GULMOHAR RESIDENCY

Details of Additions & Alterations

Flat No	207	Block no.	' G ' ✓
Flat Area	1360 sft	Type	Deluxe / Luxury
Buyer Name	Renuka A		
Phone No.	9959874169	Email

Description		Direction	Owners & Developers	Date	Prepared By	Approved By	Scale	Promoted by
WORKING PLAN-1360 Sft-A1 TYPE		N	Modi Reality Mallapur LLP Project Name & Phase : Gulmohar Residency	25.09.2020	Jayaprudha	Soham Modi	N.T.S	Modi Properties Pvt Ltd

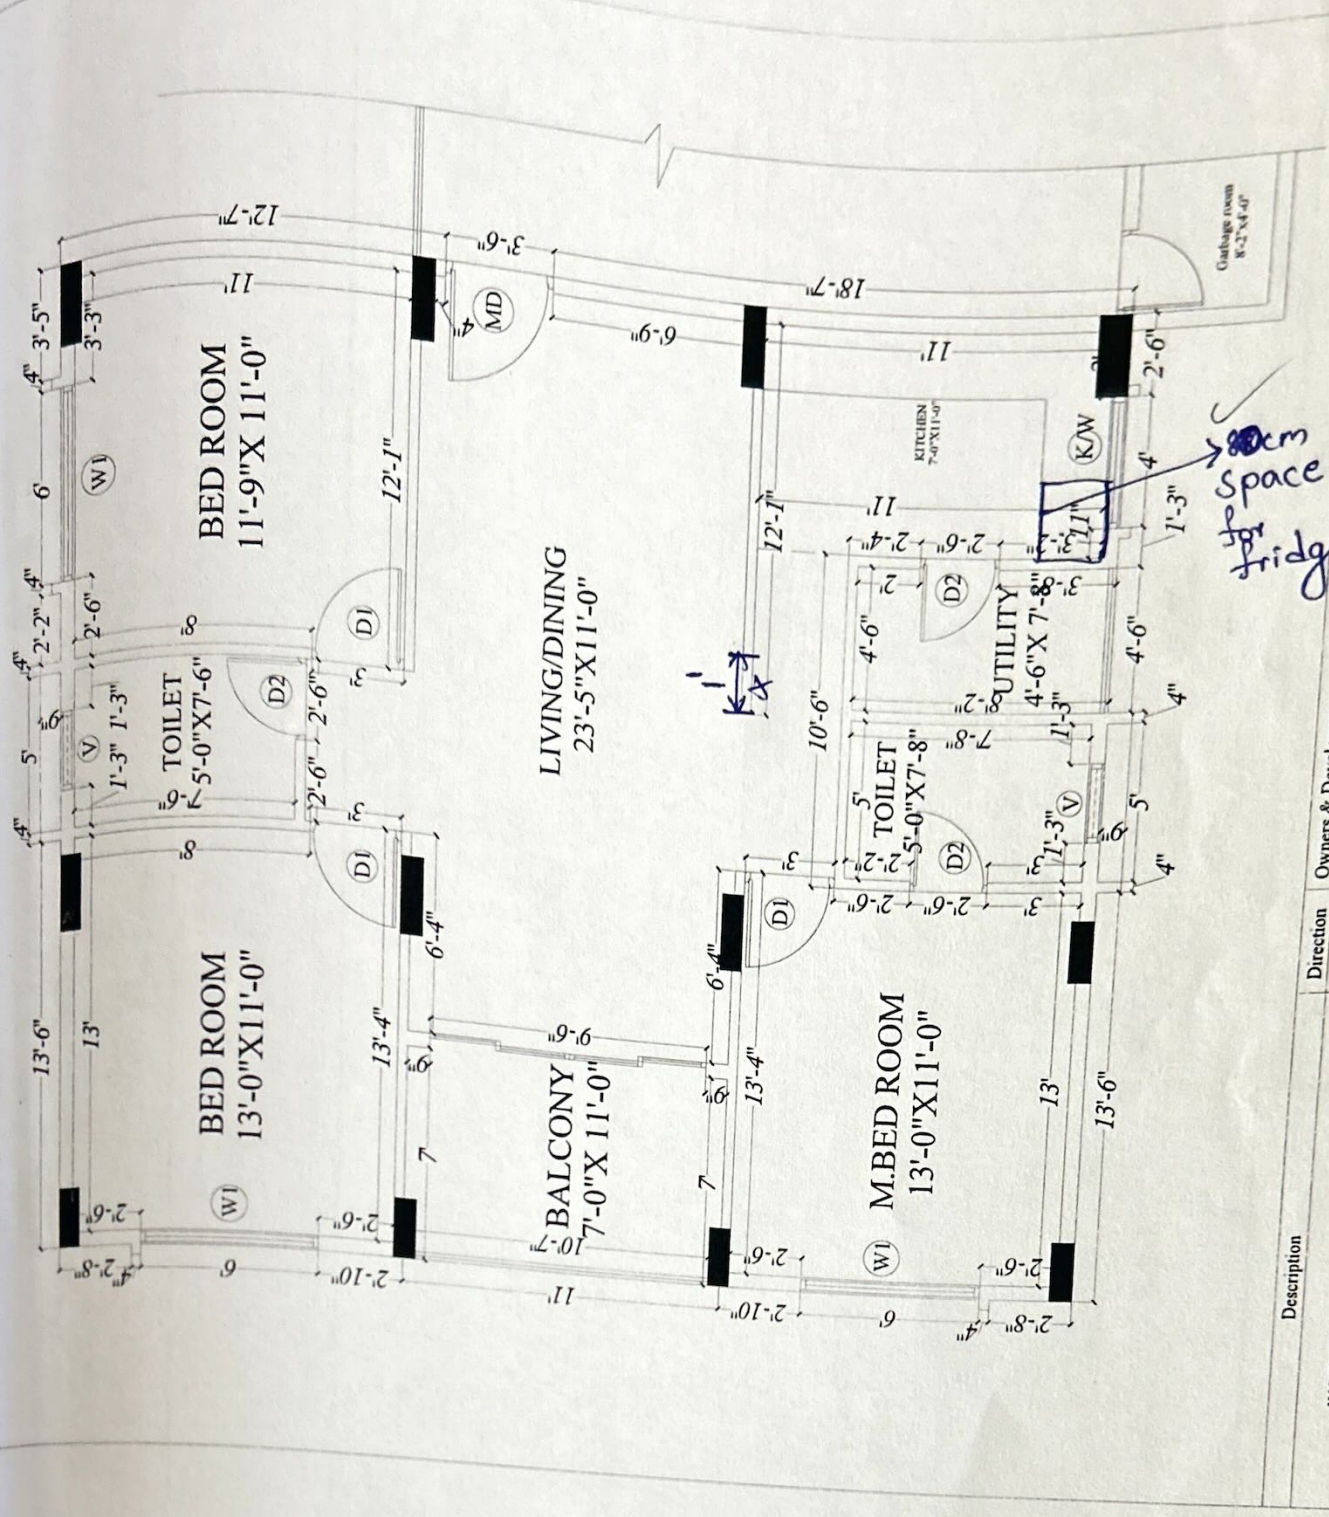
Changes in kitchen platform: (mark on plan)

① Vegetable bowl not required.

① Mesh door for Main door [A & A] Extra by customer.

② M.B K C.B by Customer (False Ceiling).

③ A-203 false ceiling in Hall & Dining [by company]

Description		Direction	Owners & Developers :	Date :	Promoted by
PLUMBING PLAN-1360 Sft (A1-TYPE)			Modi Reality Mallapur LLP	16.09.20	Modi Properties Pvt Ltd
			Project Name & Phase :	Prepared By :	
			Gulmohar Residency	Approved By :	
				Scale :	N.T.S
					Phone: +91-40-66335551

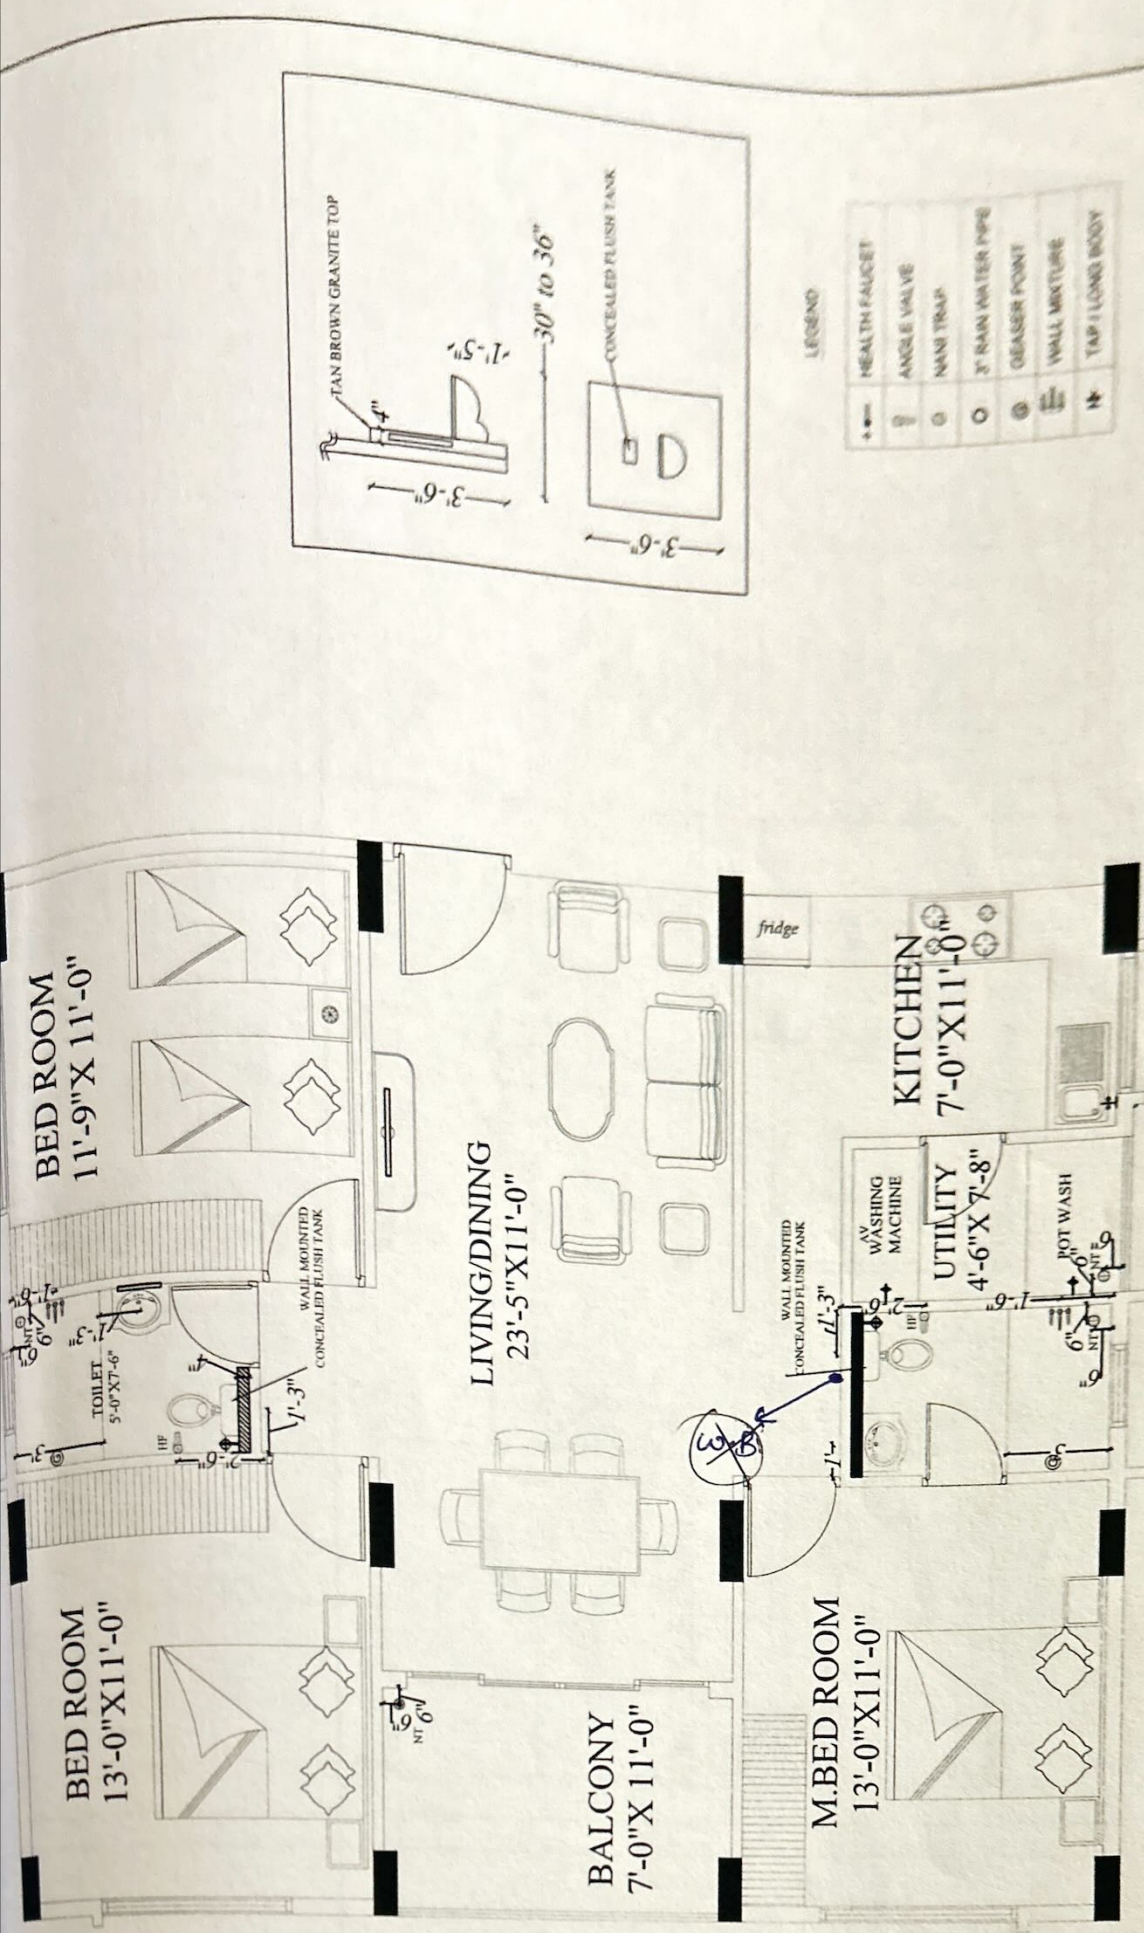
Remarks 1) As per customer's request checked and plumbing points were changed

Description ELECTRICAL PLAN - 1360 sq ft FLATS-A1 TYPE	Direction N	Owners & Developers Modi Reality Mallapur LLP	Date 21.09.2020	Promoted by Modi Properties Pvt Ltd
		Prepared By Jayapratha		
		Approved By Soham Modi		
		Scale N T S		Phone: +91-40-66335551

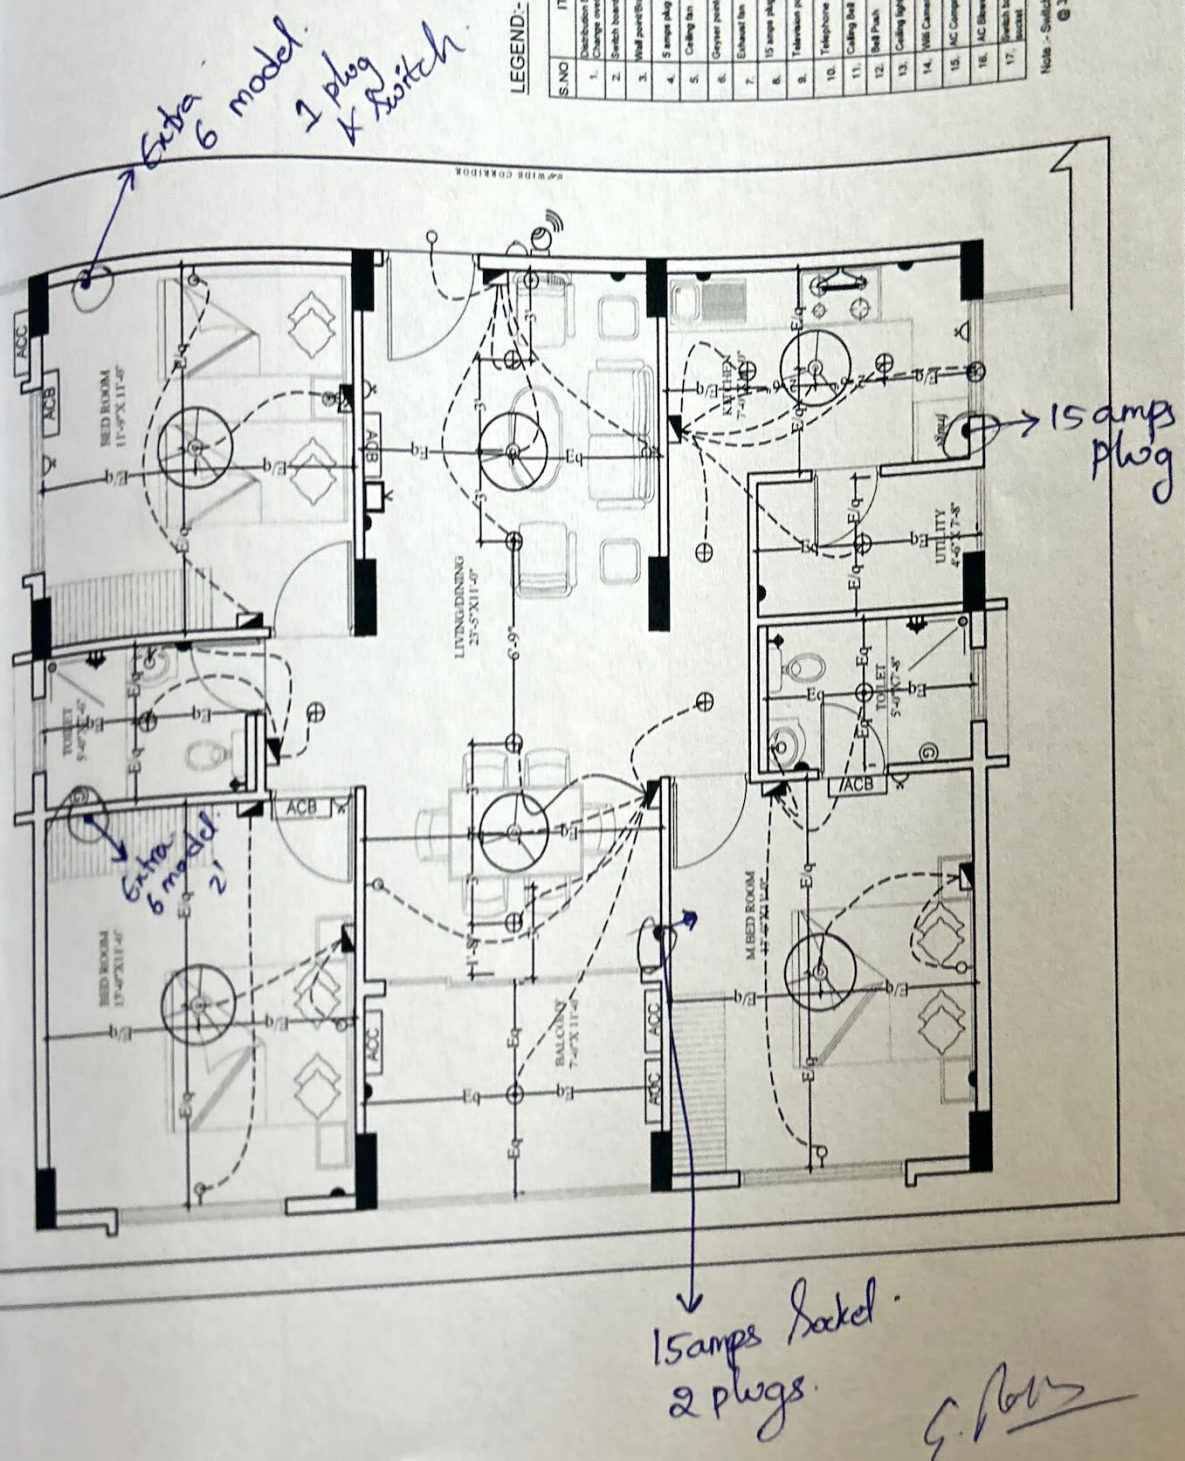
Changes in electrical points: (mark on plan)

① changes as shown in plan

15amps socket.
2 plugs.
